ADDENDUM NUMBER ONE
FOR THE
ZONE 52 WATER MAIN EXTENSION

DATE OF ADDENDUM: October 14, 2024

Changes to the Project Specifications and Construction Plans

14 OF 29

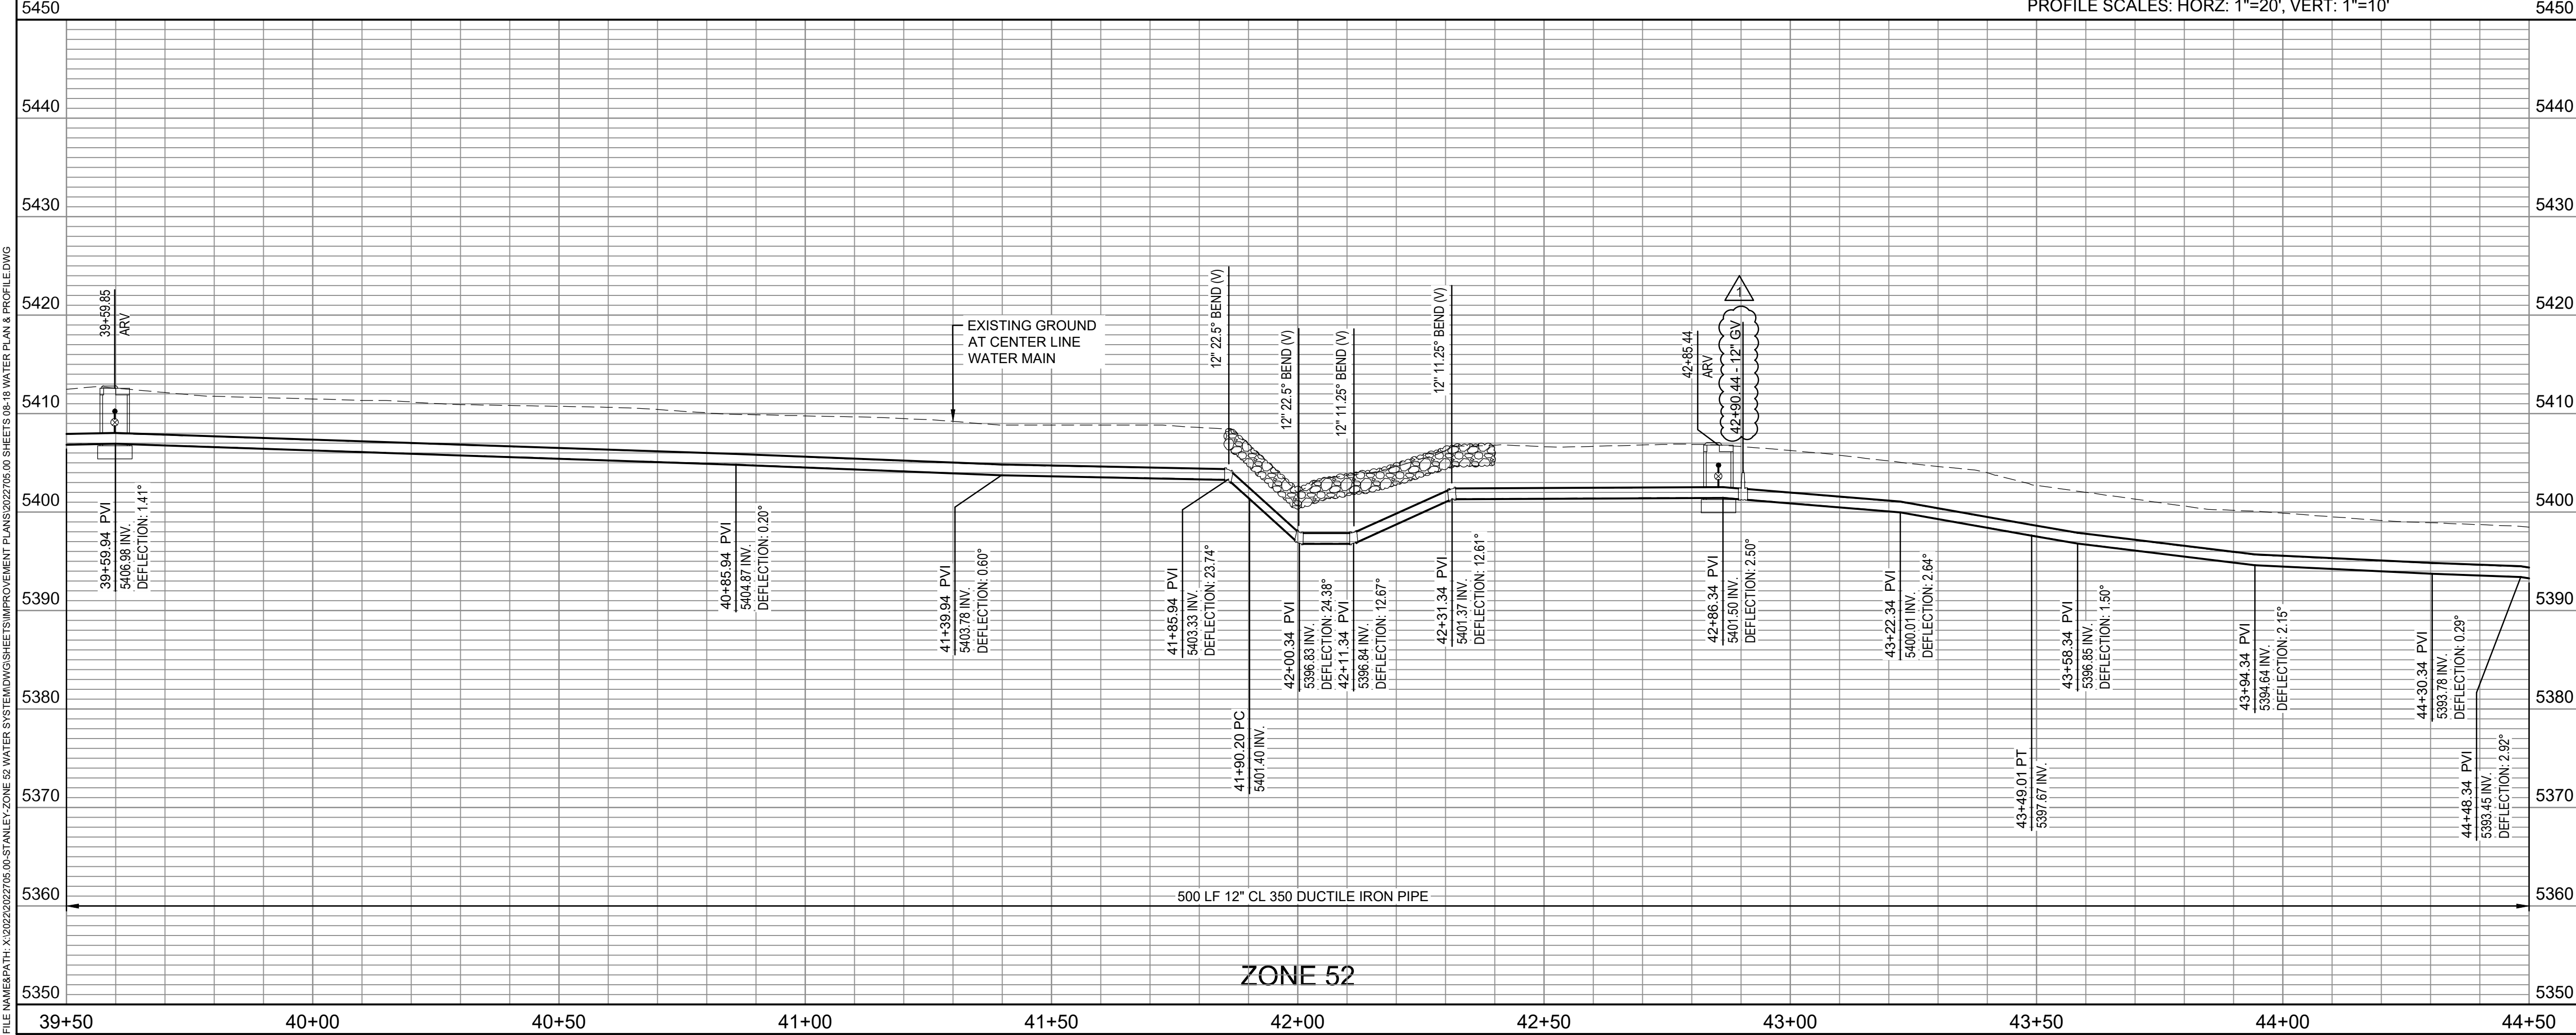
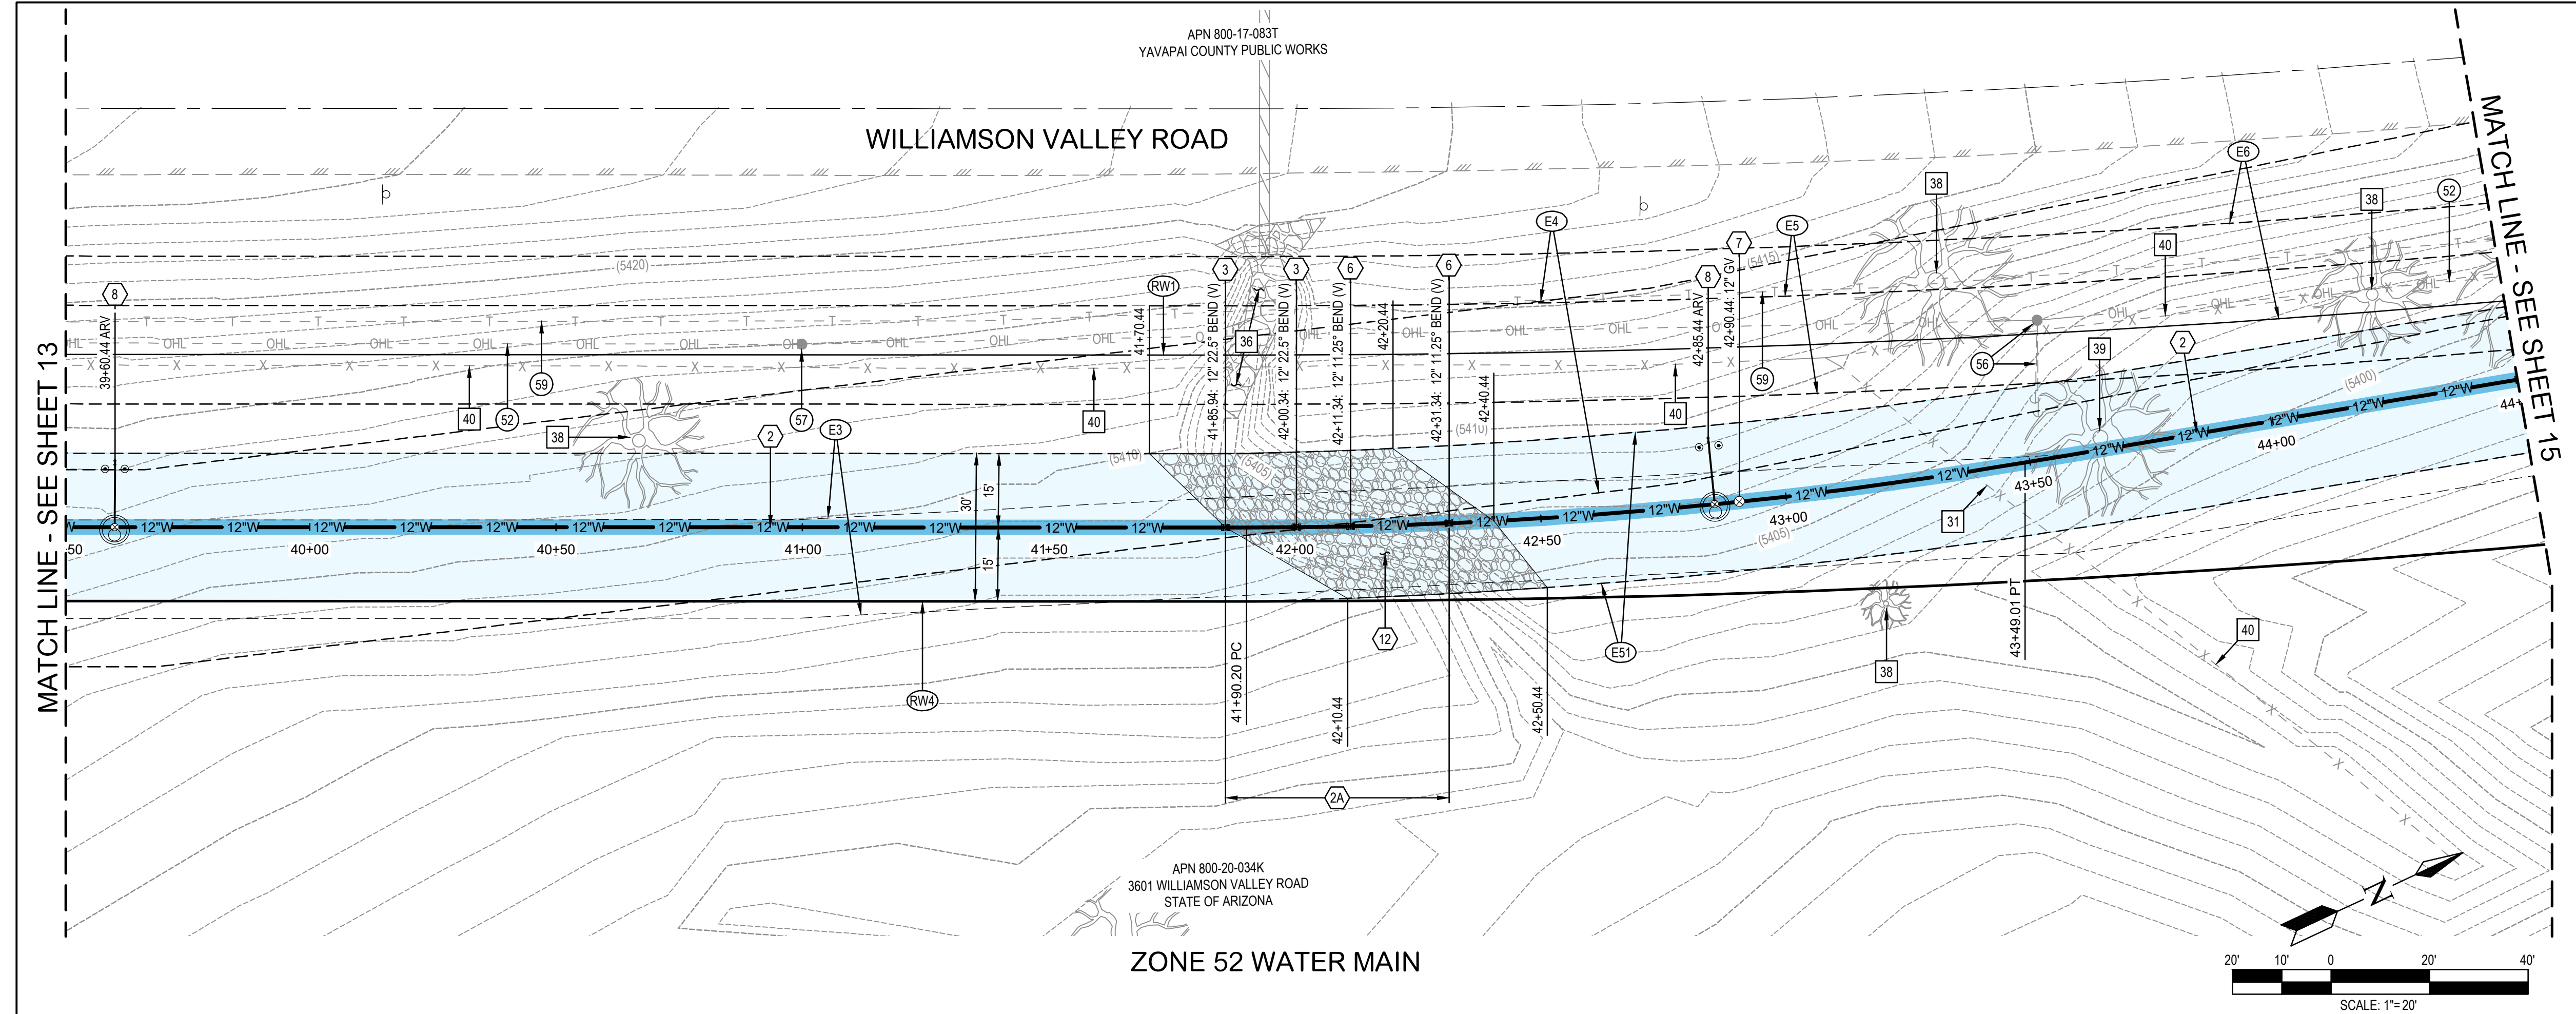
NO.	DATE
MTL	10/10/24
BY	DATE
ENGINEER	DATE
REVISIONS	
ADDENDUM 1: REVISE PROFILE STATION FOR GV	
APPR	DATE
CITY	DATE
